Re: Hillview Subdivision Traffic Analysis – Response to City Comments

## FEBRUARY 2022 CITY COMMENTS

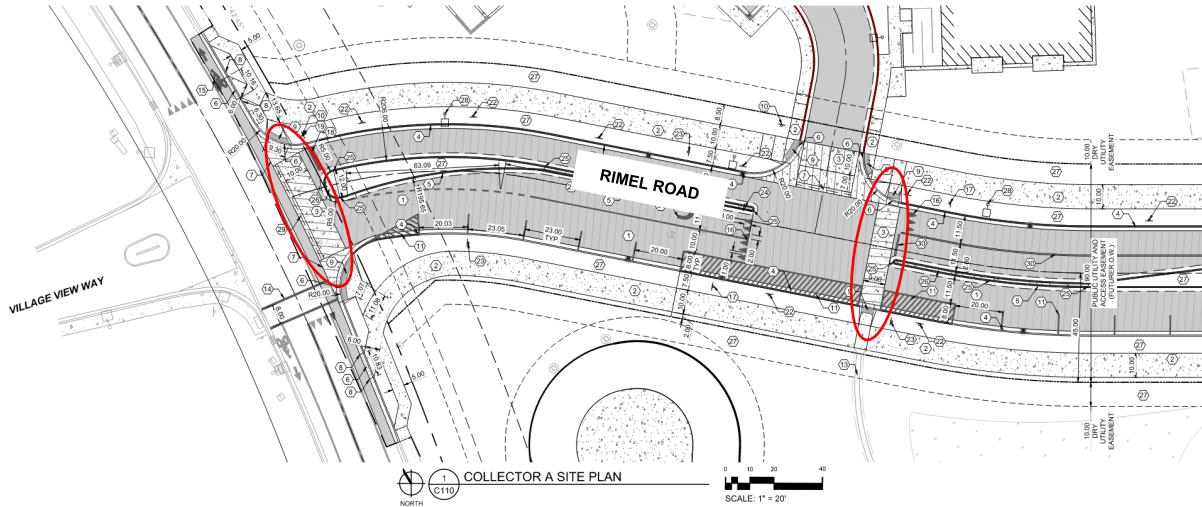
C5. *We didn’t see any pedestrian crossings of Village View Way within the Multifamily preliminary design. Would like to see multiple crossings, for both the commercial facilities and for the parkland.*

R5. As previously mentioned, commercial facilities are no longer included in the proposed development. The area south of Rimel Road is now envisioned to be a park. To address

pedestrian access to the park, the proposed development includes a crosswalk on the east leg of the Hillview Way and Rimel Road intersection. An additional crosswalk is proposed at the west driveway approach to the proposed multifamily development. These proposed crosswalks are indicated below in red.

In addition to the two proposed crosswalks shown above, a midblock crosswalk is under consideration in a future phase approximately 100 feet east of the second multifamily approach (not shown above). Please note, the eastbound left-turn lane on Rimel Road shown above is no longer being proposed based on a turn lane analysis described in the **Turn Lane Warrant Analysis – Summary of Results** section of this letter.

FIGURE 6: PHASES 2-7 SITE TRAFFIC ARRIVAL PATTERN

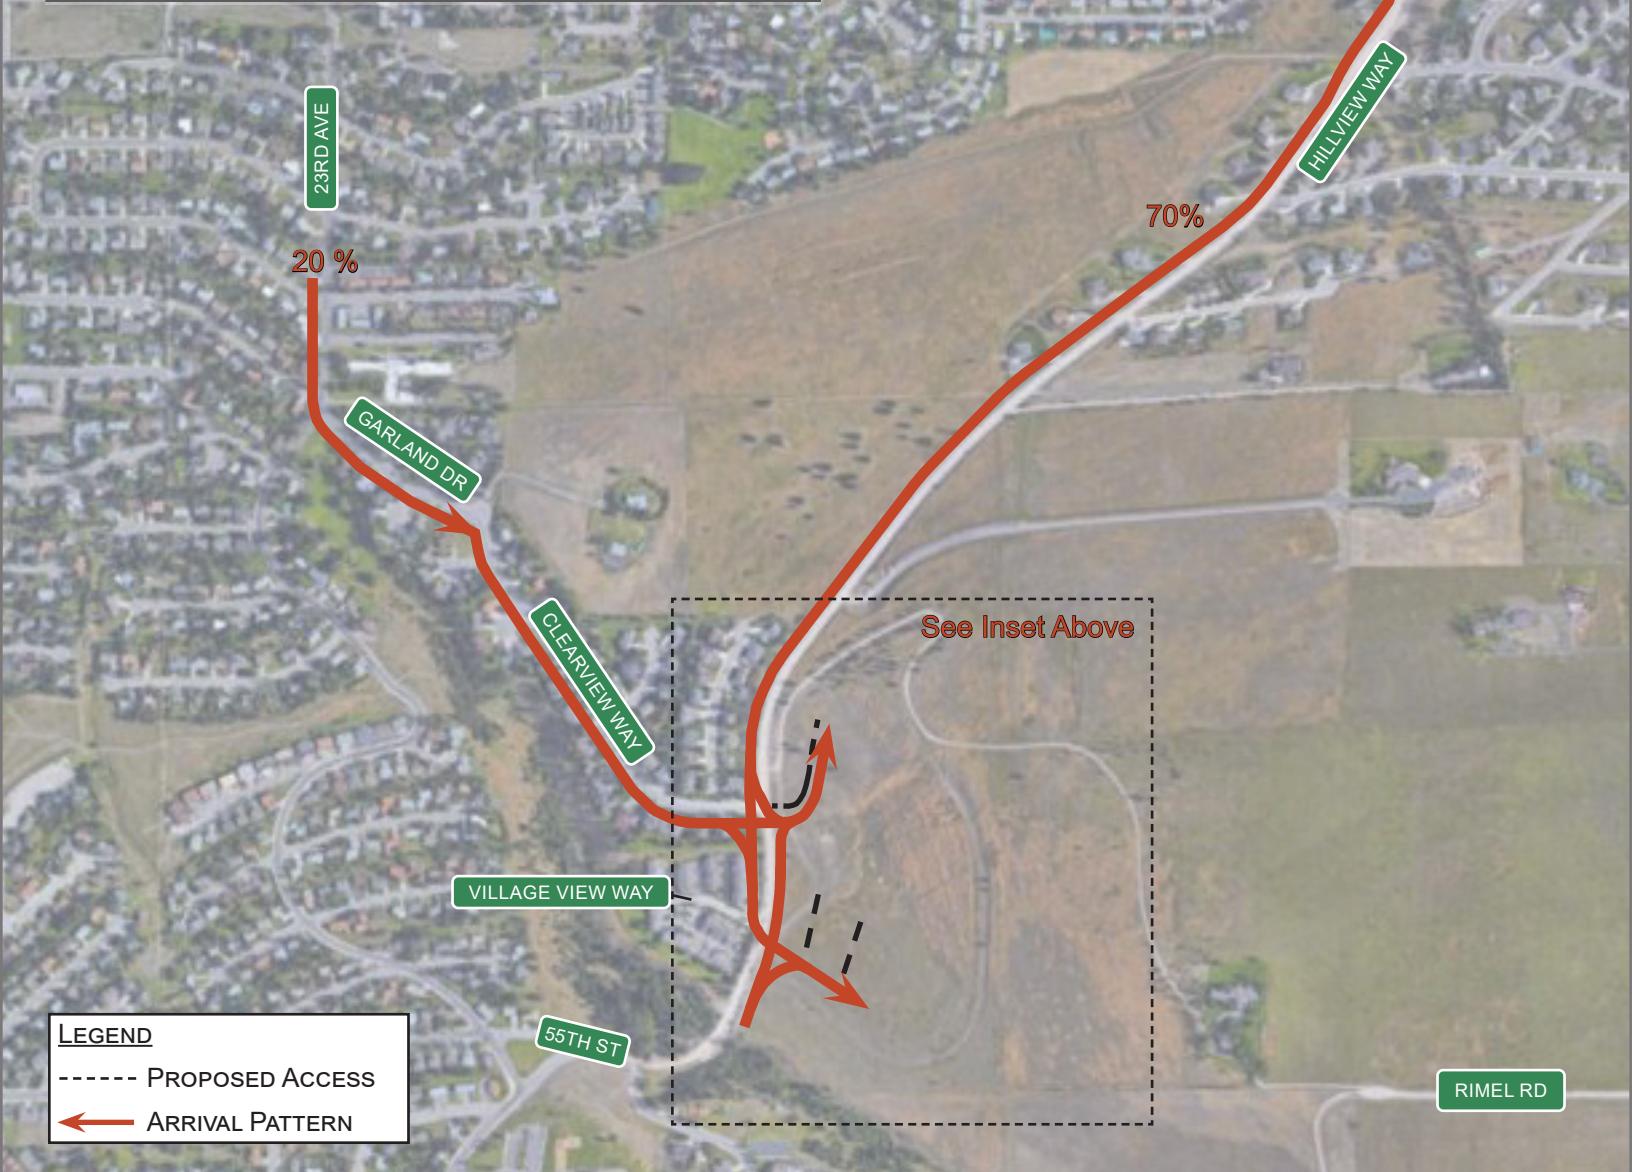
C3. *What is the rationale for assigning 20% (of site-generated traffic) to SB on Hillview Way? And later as part of additional email comments from the City - Need to determine split between those who use 23<sup>rd</sup> St vs Hillview Way. This % should be used to show volume that would use Clearview vs Hillview. 23<sup>rd</sup> is a more direct route to US 93 and US 12.*

R3. As directed in separate correspondence from the City, turning movement volume data was collected at Hillview Way and 23<sup>rd</sup> Avenue to determine the proportion of site-generated traffic that may utilize 23<sup>rd</sup> Avenue for trips to/from Reserve Street and US 93 South. Cushing Terrell collected this additional **Traffic Count Data** in August 2022, included in this letter. Based on the existing traffic patterns observed at Hillview Way and 23<sup>rd</sup> Avenue it was estimated that a 70/20/10 split for site-generated traffic would more closely match existing travel patterns, with 70 percent of site-generated traffic expected to travel north on Hillview Way toward 39<sup>th</sup> Street, 20 percent expected to take Clearview Way/Garland Drive west to then proceed north on 23<sup>rd</sup> Street toward Reserve Street or US 93 south, and 10 percent expected to travel south on Hillview Way toward Gharrett Street via 55<sup>th</sup> Street. The anticipated arrival and departure patterns for both Phase 1 and Full Buildout of the proposed development are illustrated in **Figures 4 – 7** following this letter.

#### GUIDELINES FOR RIGHT-TURN LANES AT UNSIGNALIZED INTERSECTIONS ON 2-LANE HIGHWAYS

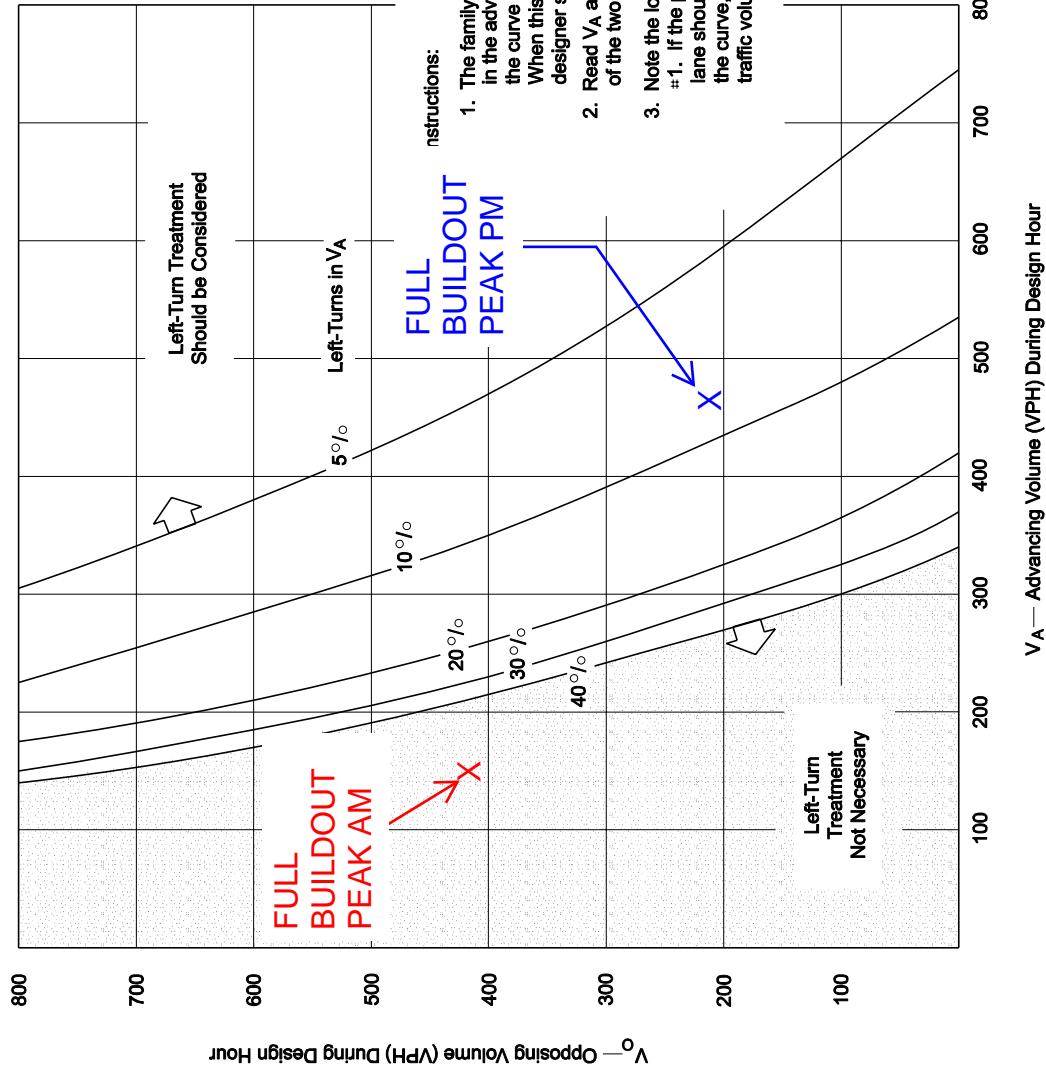
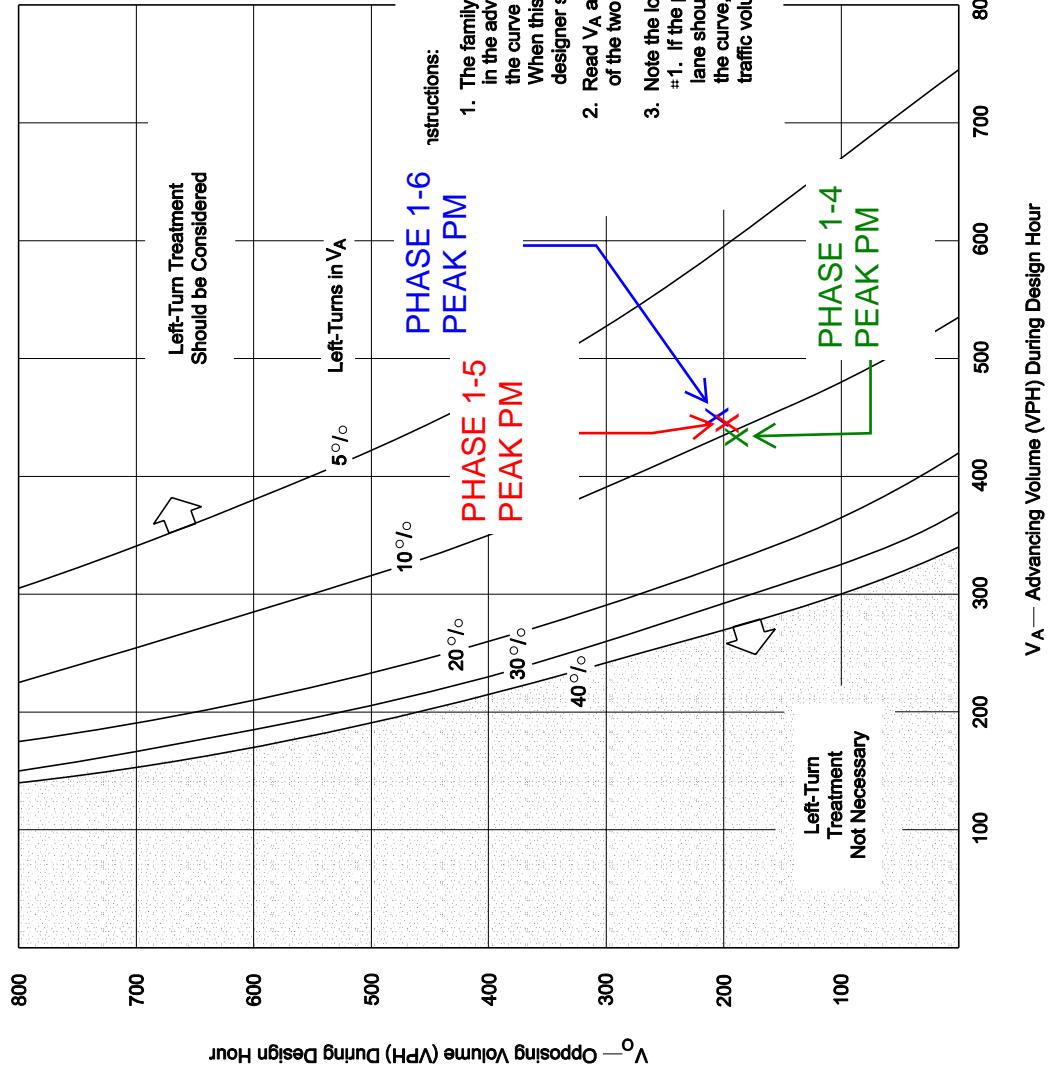
C4. *(Hillview) Way already has a dedicated right turn lane (at Clearview Way). 3 SB lanes plus a NB lane will create a long crossing distance for pedestrians. Please elaborate on ped crossing treatments.*

C6. *(Pointing to the existing southbound right-turn volume on Hillview Way at Clearview Way) - Does this justify the existing right-turn bay? Could it become a thru/right lane and use the existing thru as a left turn?*

R4. Right-turn lane and left-turn lane warrants were checked for this intersection and completed **Turn Lane Nomographs** are enclosed with this letter. It was determined that the existing southbound right-turn lane on Hillview Way at Clearview Way is not warranted either presently or after the addition of the development traffic. However, a left-turn lane will be warranted at this location during buildout of Phase 5 of the Hillview Subdivision. The existing southbound right-turn lane can be removed to shorten the crossing distance if that is the City’s preference.

R6. As described above in **R4**, the existing southbound right-turn lane on Hillview Way at Clearview Way is not warranted based on existing or future traffic volumes. It is recommended that the geometrics of this intersection be constructed with the added left-turn lane in a manner that avoids alignment shifts for through traffic.

The existing southbound right turn lane is not warranted based on the existing and full buildout volumes.
